**Amendments to the draft AEBS
(based on AEBS skeleton mitigation Rev.2 Add. AEBS-M),**

Drivers' avoiding maneuver for forward obstacles

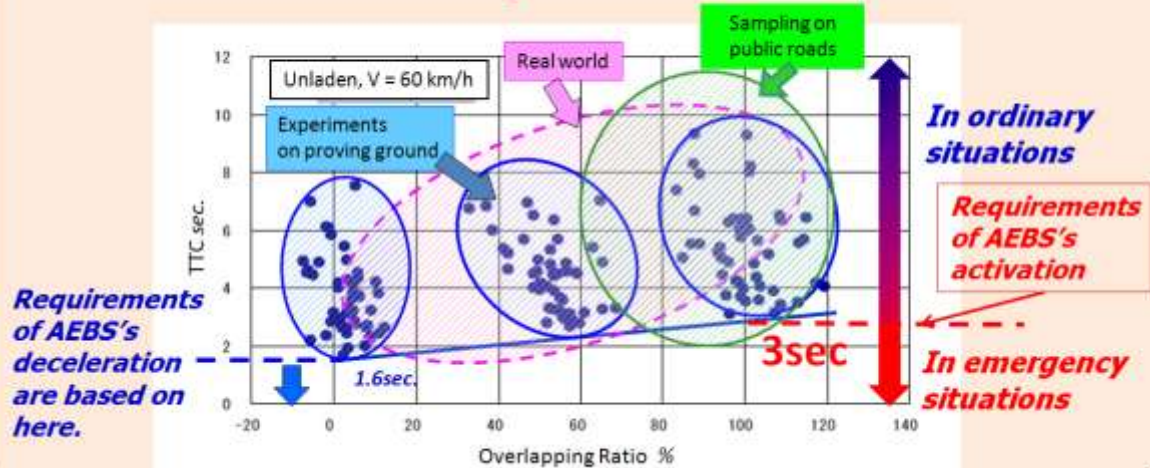
- **Most drivers operate braking to avoid a collision at the earlier time than 1.6s at most of overlapping ratio.**
 - ➔ There is no interference with drivers' operations.
 - ➔ The speed reduction of Japan proposal is based on 1.6s.
- **Most drivers operate braking to avoid a collision at the earlier time than 3.0s in conditions of overlapping ratio 100%.**
 - ➔ It is the number which distinguishes an ordinary driving from an emergency operation to avoid a collision.

{6.7.4. The Emergency braking phase shall not start before TTC reaches down to 3.0 seconds.}

{6.7.5. The maximum braking demand ~~for N-category~~ shall be equal to or more than 4m/s^2 }
